Project: **7 Warwick Court**

Drawing Title: **Demolition & Proposed Roof Plan**

Drawing No. **P_06** Rev. **D**

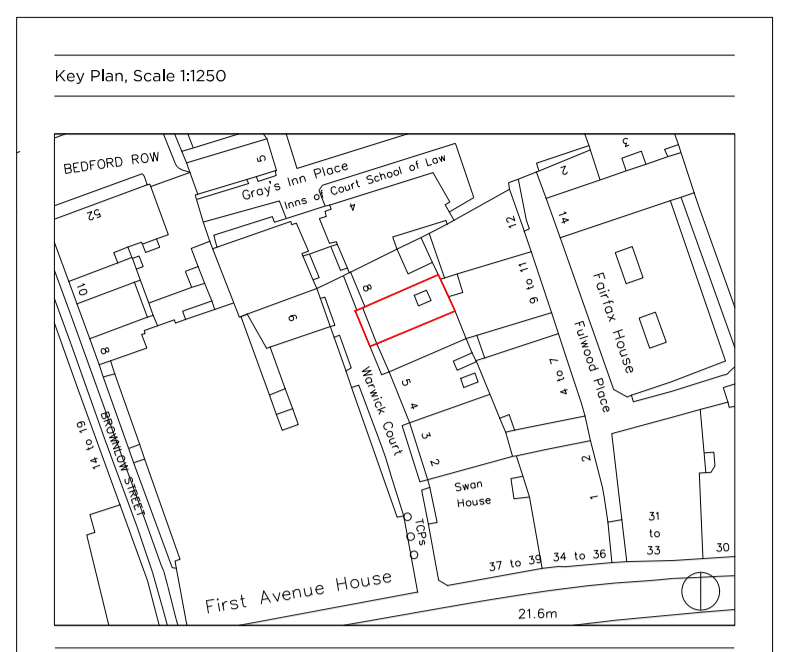
- B. Revision Note:**
- 1. Proposed rooflights reduced in height.
 - 2. Proposed window now removed.
- C. Revision Note:**
- 1. Existing dormer windows to be retained.
 - 2. Mansafe restraint system added.
 - 3. Rooflights repositioned to work with reconfigured layout below.
